# City of Albuquerque

RE: AS-BUILT DRAINAGE PLAN FOR ARBY'S RESTAURANT  
REVISION DATE OF MARCH 2, 1989 (K-10/D20A)

**ARBY'S RESTAURANT**  
**COORS & CENTRAL SHOPPING CENTER**  
**GRADING & DRAINAGE PLAN**

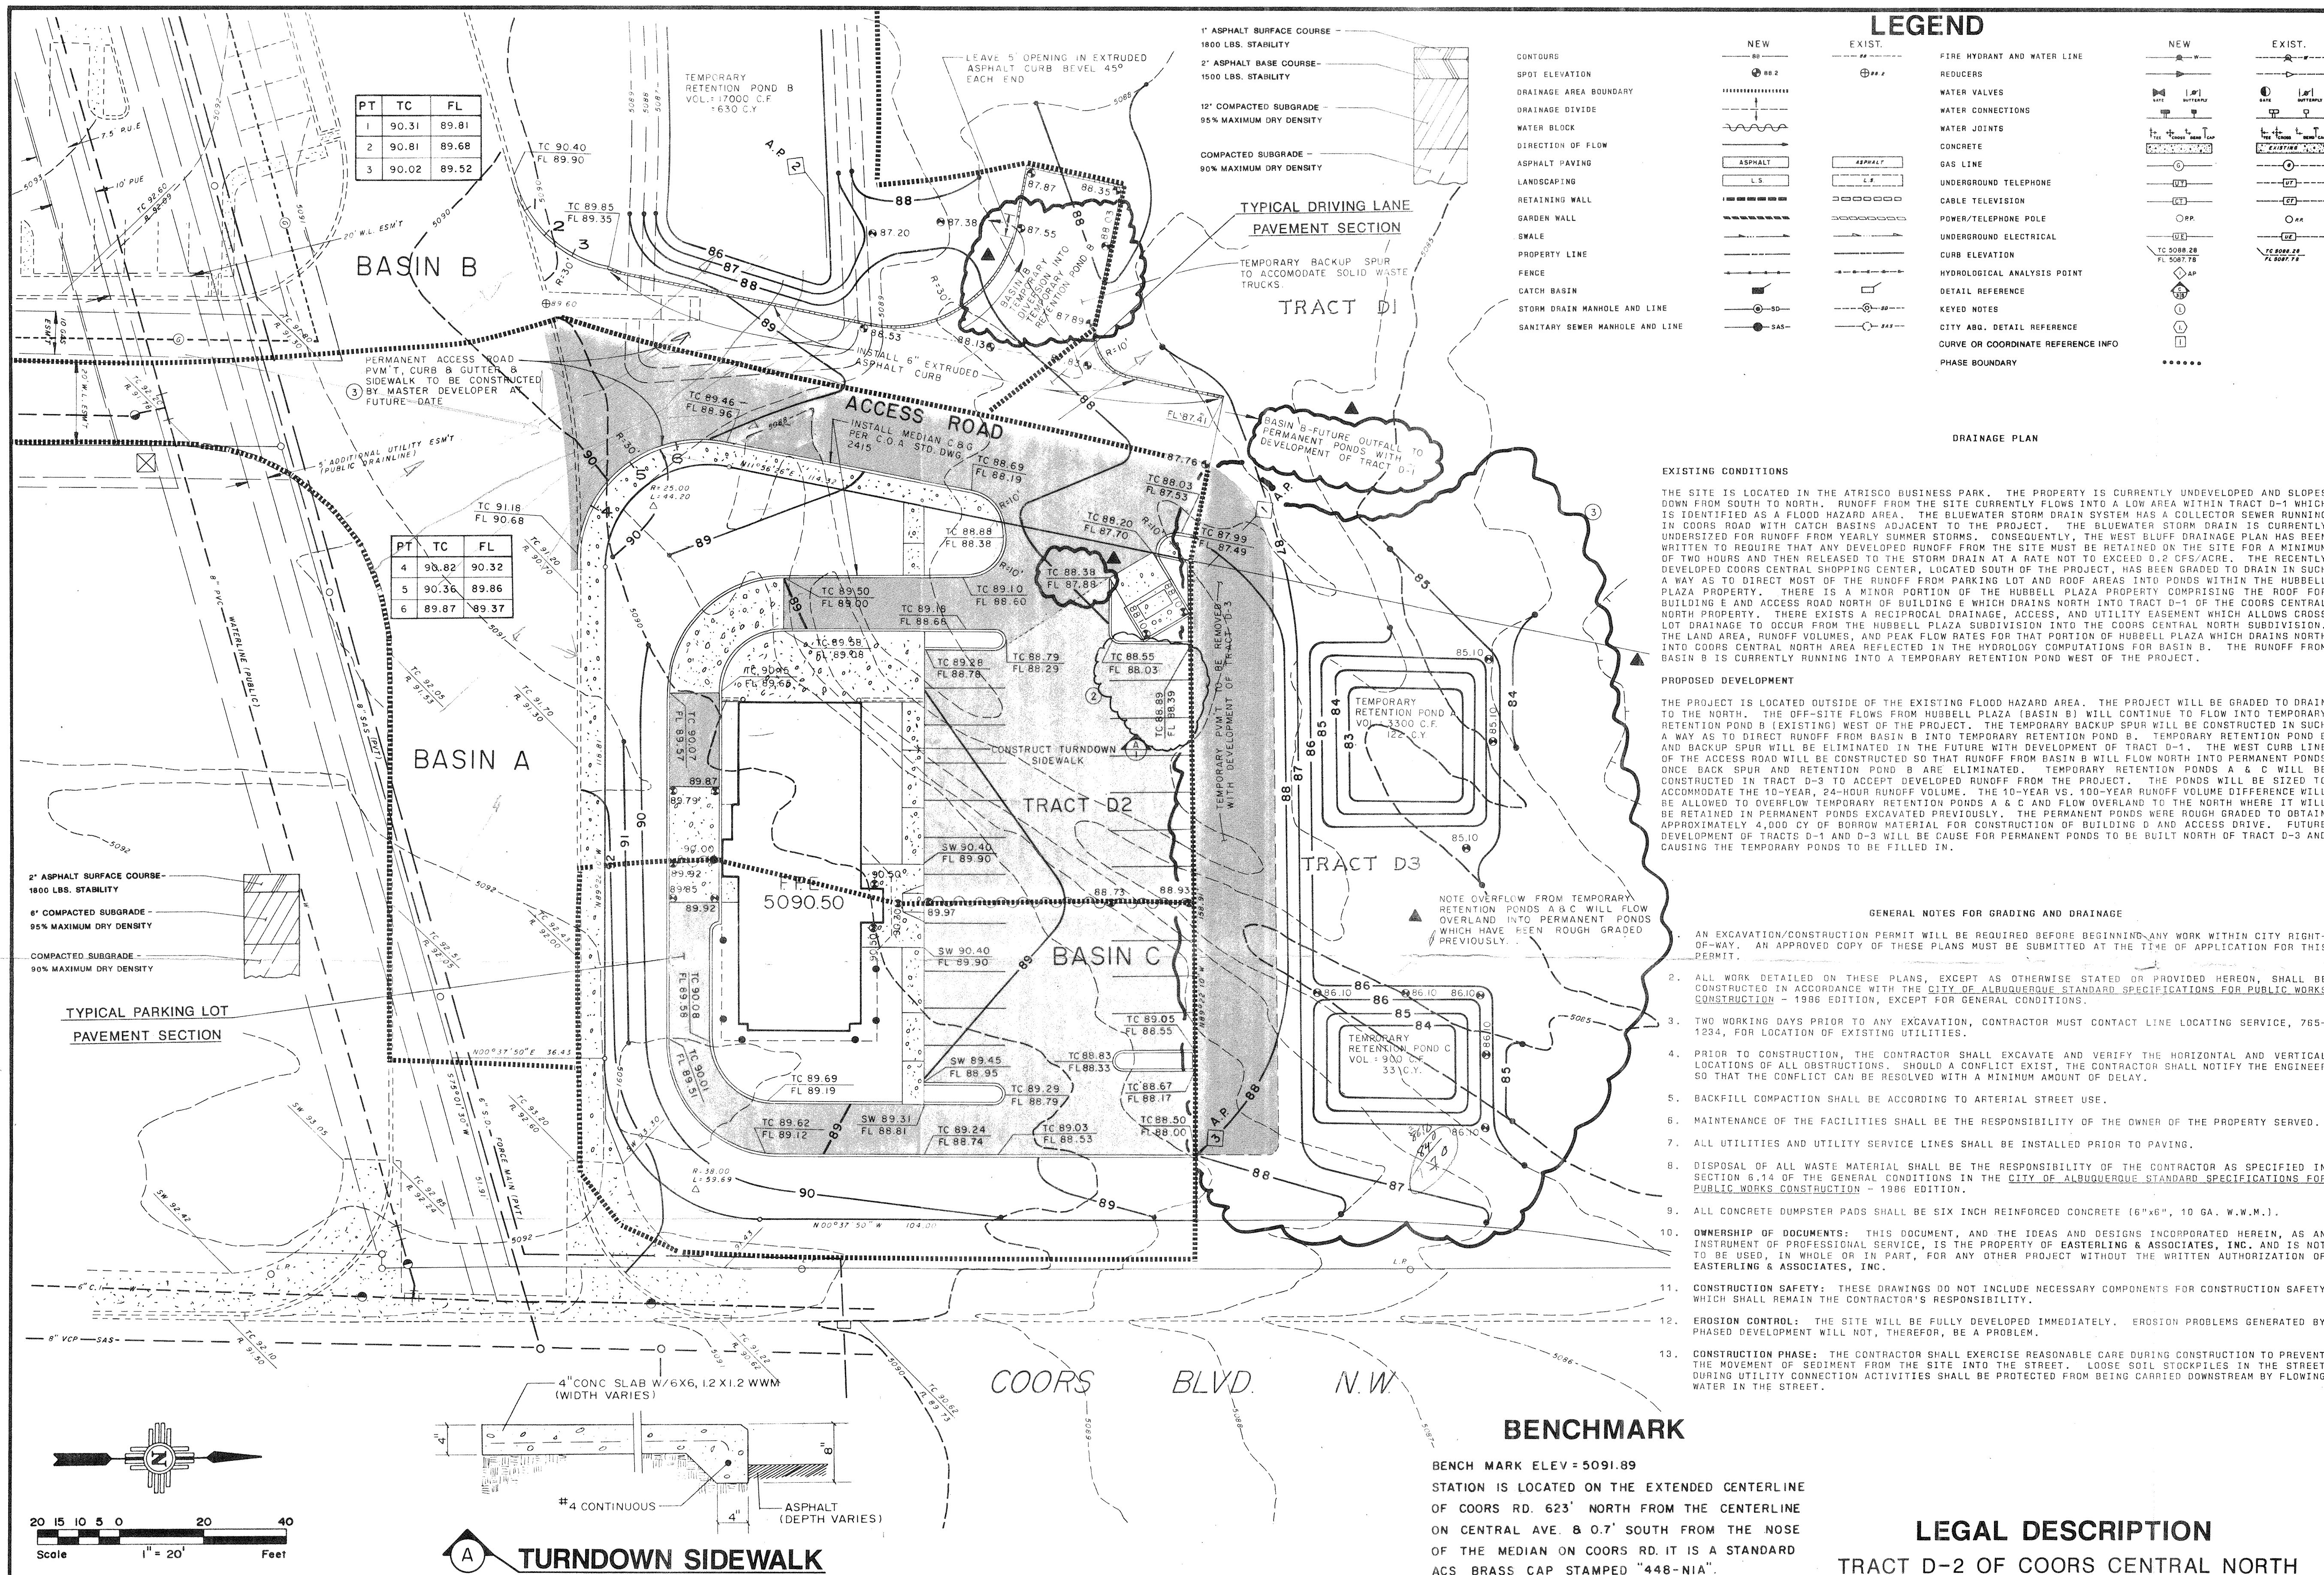
Based on the information provided on your resubmittal of March 6, 1989, the as-built conditions as shown are acceptable for Certificate of Occupancy release.
